Technical Bulletin

ERRATA # 0183 20190507 GSV Sentence

NMEA 0183 4.11

GSV – GNSS Satellites In View

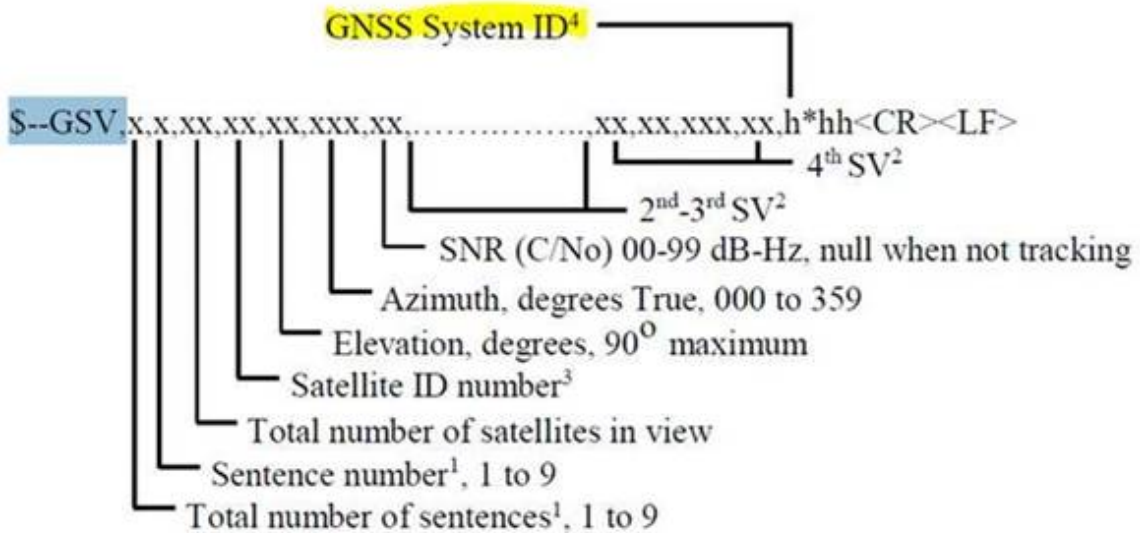
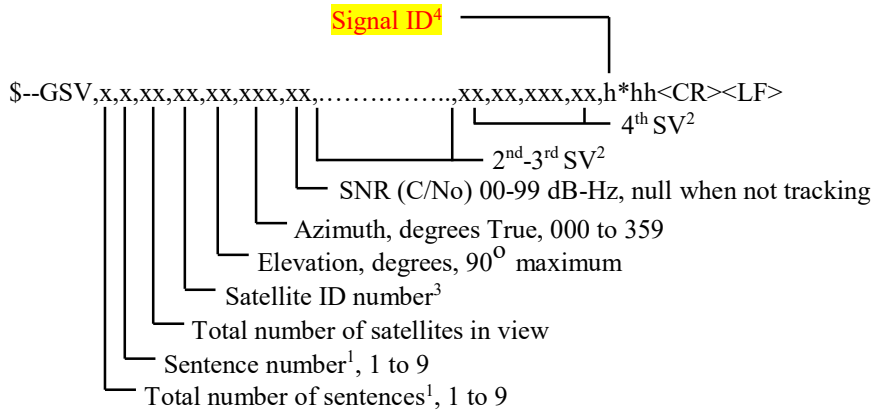
In the GSV – GNSS Satellites In View sentence the GNSS System Field as highlighted is incorrect. This Field should read Signal ID. See correction below.

This is incorrect:

CORRECTION:

This will be corrected in the next publication of NMEA 0183.
